Peer-to-peer File Sharing Traffic Model for IEEE 802.16m EVM

IEEE S802.16x-08/060

IEEE C802.16m-08/060

Figure 1: BitTorrent traffic pattern

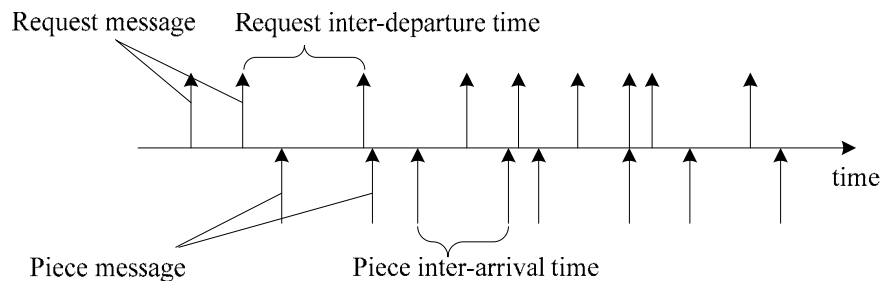
-----Start of the Text-----
[In IEEE 802.16m-07/037r2, insert the following section after section 10.7]

10.8. Peer-to-peer File Sharing Traffic Model

For simplicity, all leech peers (peers that do not have the entire content) are assumed to be interested in a piece of infinite size, and will not be choked by any remote seed peers (peers that have the entire content). Therefore, leech peers continuously send requests for blocks and receive piece messages containing the requested blocks. Both the request inter-departure time and piece inter-arrival time can be modeled by the exponential distribution [3], [4], [5]. The simplified BitTorrent traffic pattern is illustrated in Figure 1.

The parameters for the BitTorrent traffic model is listed in Table 1 [3], [4], [5]. Additional network protocol overhead, such as IP and TCP headers, should be added to each message generated by the BitTorrent traffic model described in Table 1.
